STAFF REPORT

ITEM: Wyndham Village Preliminary Plat and Zoning Map Amendment

Re: Wyndham Village Preliminary Plan Review

PRELIMINARY LANDSCAPE LAYOUT PLAN:

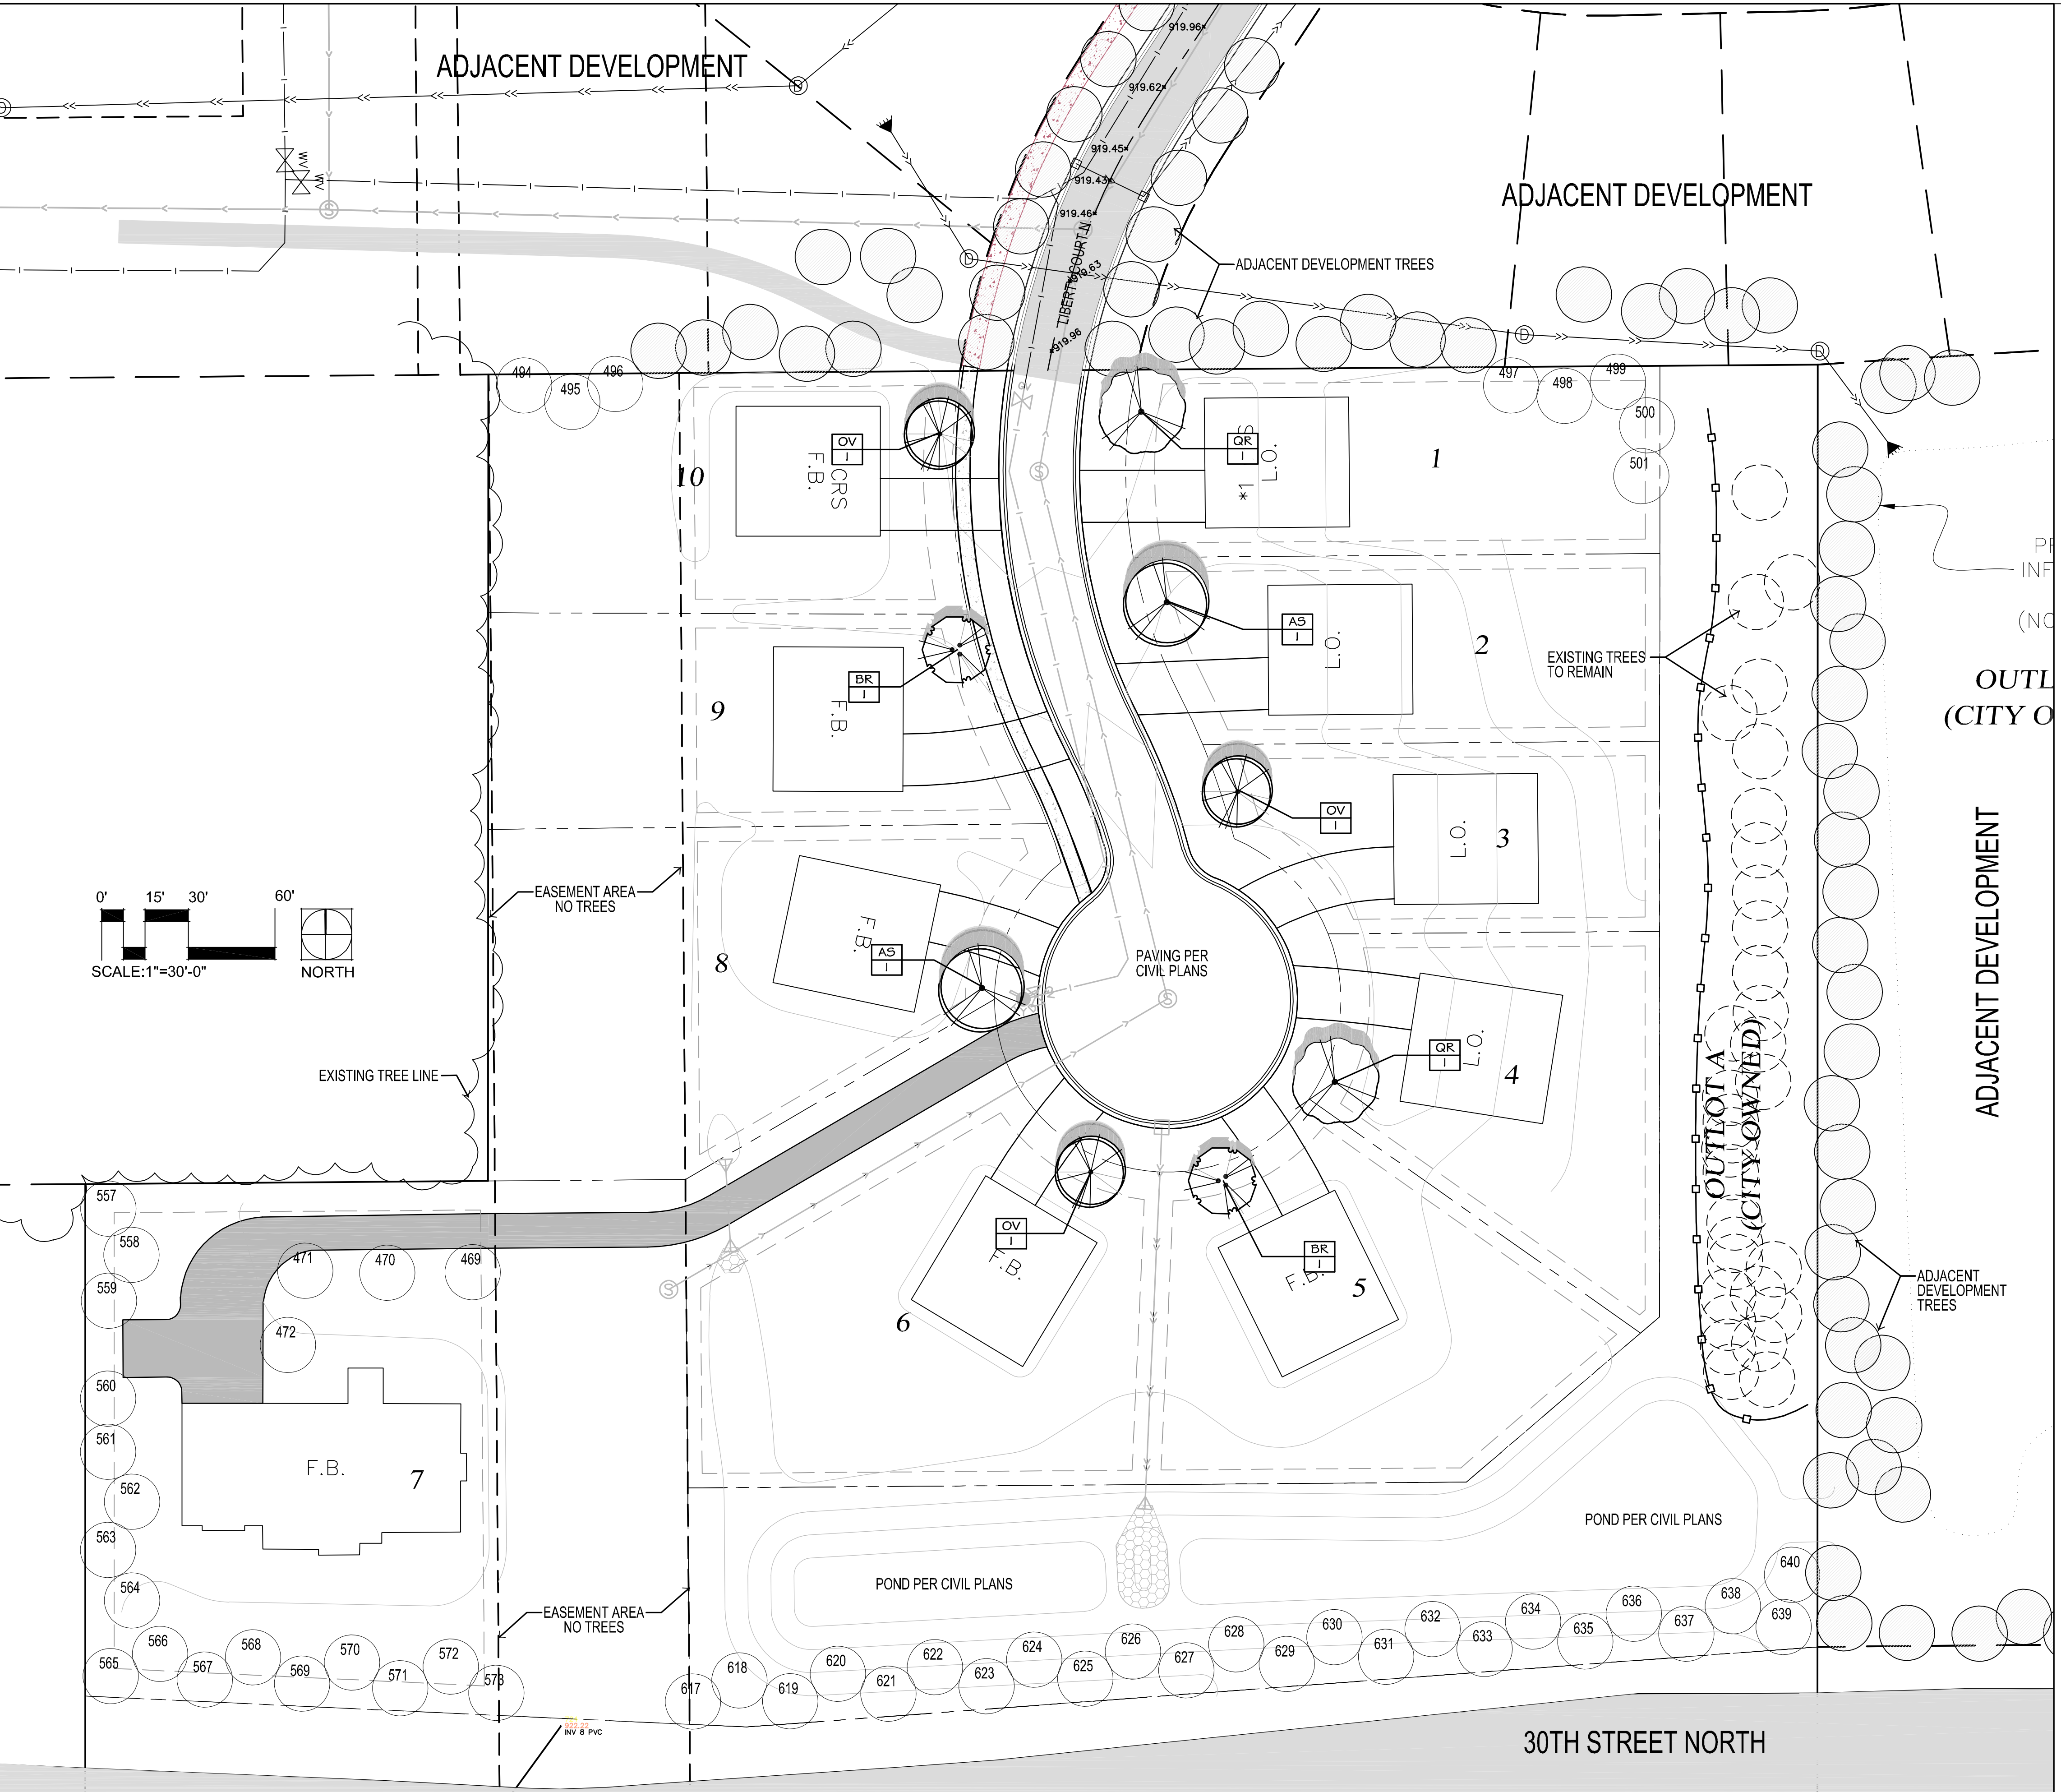
- This review does not cover the Landscape Plan or Irrigation Plan. Plan review to be completed by other City representatives.
- The Landscape Plans must be revised to accommodate maintenance access to all storm water BMPs. Grades along pond access cannot exceeded 10% and must be a minimum of 20 feet in width. Maintenance access from public right-of-ways must be shown on the Landscape Plans.

The Preliminary Landscape Plan appears to indicate that many existing trees will be relocated to a new location on the site. MAC requests that, if feasible, any new trees introduced to the site be of a non-fruit bearing species to minimize wildlife attractiveness. The City must also be aware that any trees planted in the vicinity of an approach to a runway may require removal or trimming (at the Owner's expense) at some future date if they grow to become an obstruction to the airspace of the Airport or compromise flight procedures.
